<u>Preliminary Subdivision & Site Plan Application Additional Materials: Highland Views</u> <u>Manufactured Housing Park & Mixed Use Development</u>

Subject: Comment Response – Highland Views

In response to the recent review provided by Jonathan R. Earle, Town Engineer for Windham, regarding the geology and stormwater review of the Highland Views project, we would like to offer the following responses:

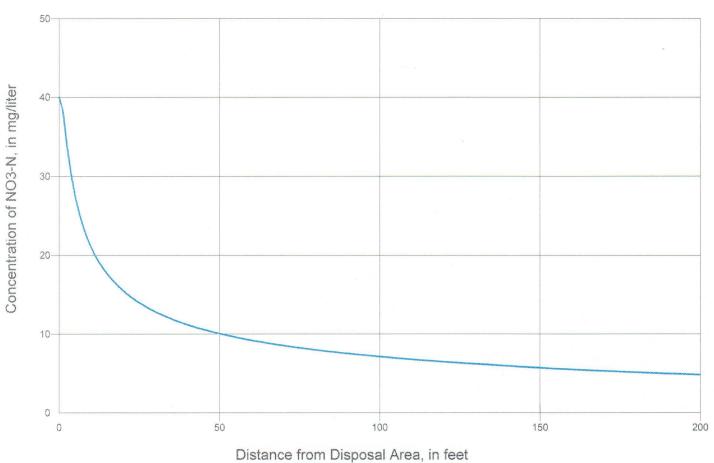
Comment 3: Hydrogeologic Assessment. An site plan with contour information showing the reduction of nitrate/nitrogen in the plume from the centralized subsurface wastewater disposal field should be included as part of the hydrogeologic analysis as specified in section 910 of the Subdivision Ordinance "An analysis and evaluation of the effect of the subdivision on groundwater resources. In the case of residential developments, the evaluation shall, at a minimum, include a projection of post development nitrate/nitrogen concentrations at any wells within the subdivision, or at the subdivision boundaries; or at a distance of 1,000 feet from potential contamination sources, whichever is a shortest distance."

Response: The nitrate plumes have been added to the utility plan (C-4.0).

Calculations were made and reveal the 10 mg/liter NO3-N plume will be approximately 50 feet in length. A plot of the concentration versus distance curve is enclosed. Using the inferred ground water flow direction, the calculated 10 mg/liter NO3-N isocon lines were drawn on the plan of the project by Mark Cenci Geologic, Inc. and forwarded to Terradyn Consultants. All plumes will eventually filter through wetland soils before seeping into Highland Lake.

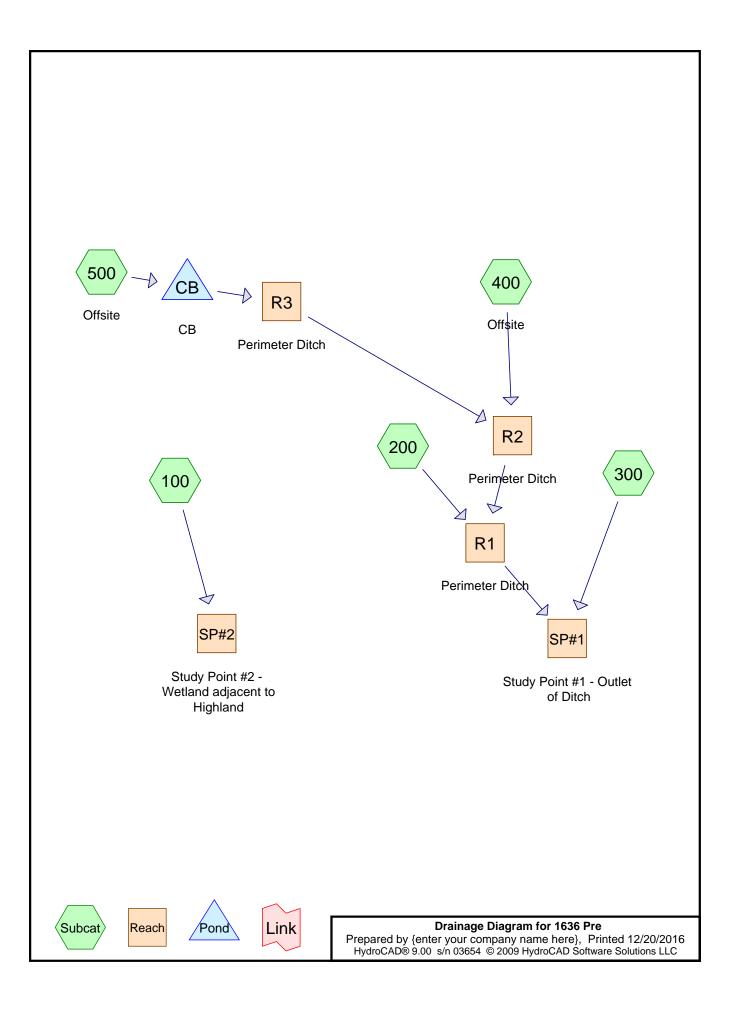
Comment 10: Stormwater. Worksheet 1 (Project Phosphorous Export) – Calculations submitted indicate post-treatment phosphorous export will be reduced to below predevelopment levels. However, the sheet indicates that there will need to be a negative compensation fee paid as part of the project. The worksheet should be revised to indicate that no compensation fee will be required for the project.

Response: The worksheet has been corrected.
